UNITED STATES PATENT AND TRADEMARK OFFICE

APPLICATION NO.	FILING DATE	FIRST NAMED INVENTOR	ATTORNEY DOCKET NO.	CONFIRMATION NO.
10/815,581	03/31/2004	Michael J. Antal JR.	UOHIP006D1	9383

Office Action Summary

DETAILED ACTION

Figure 2. Schematic of the laboratory reactor.

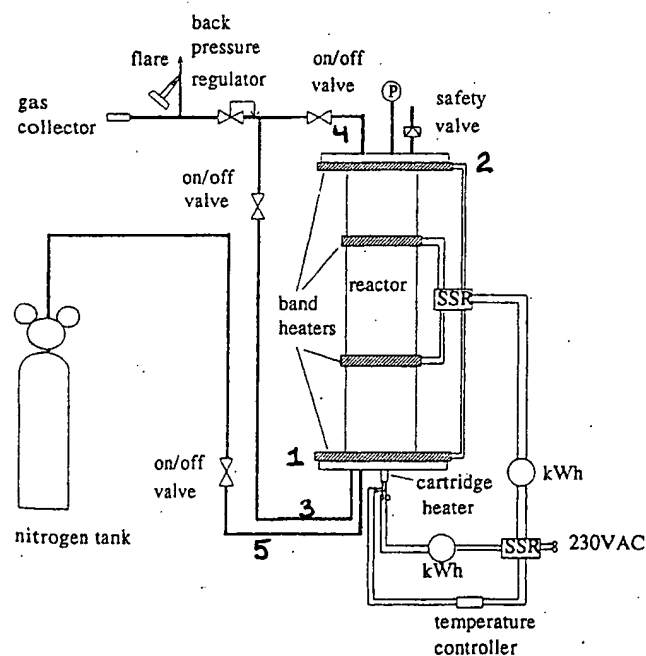
With respect to claim 20, Antal Jr. et al. discloses a reactor (figure 2) which comprises a housing (pressure vessel) with a sealable opening (pressure-tight hinged closure) for receiving a removable canister with a lid; heaters which heat the distal end (2) of the canister (fig. 2) (page 653, col. 2, paragraph under "Apparatus and

Experimental Procedures"); a first valved exit orifice (3) at a proximal end (1) and a second valved exit (4) orifice at a distal end (2) of the housing (pressure vessel); and a valved entry orifice (5) at the proximal end (1) (page 653, col. 2, paragraph under "Apparatus and Experimental Procedures").

Figure 2 of Antal Jr. et al. does not provide reference numbers, so the examiner has numbered various elements below to provide further clarification of how the reference has been applied.

Antal Jr. et al. discloses band heaters in locations in addition to the distal end and fails to disclose locating a heater solely at the distal end.

Antal Jr. et al. also fails to disclose any insulation in the device.

With respect to claim 22, Antal Jr. et al. further discloses wherein a flare (burner) is in communication with the second valved exit (4) (see figure 2).

With respect to claim 24, the schematic illustration of Antal Jr. et al. has been applied so that the proximal end (1) is at the bottom and the distal end (2) is at the top of the vertically arranged device shown in figure 2. The device of Antal Jr. et al. arranged so that the proximal end (1), and its associated elements, is at the top while the distal end (2), and its associated elements, is at the bottom of the vessel would still be the same apparatus (only turned on end). It appears from the description of the operation of Antal Jr. et al.'s device, that in such an orientation, the device would continue to be operational. It has been held that there is no invention in shifting the location of parts when the operation of the device would not thereby be modified. In re Japikse, 86 USPQ 70 (CCPA 1950).

The schematic of the apparatus of Antal Jr. et al (figure 2) only illustrates that the valved entry (5) passes into the proximal end (1) but fails to illustrate if it extends into the canister.
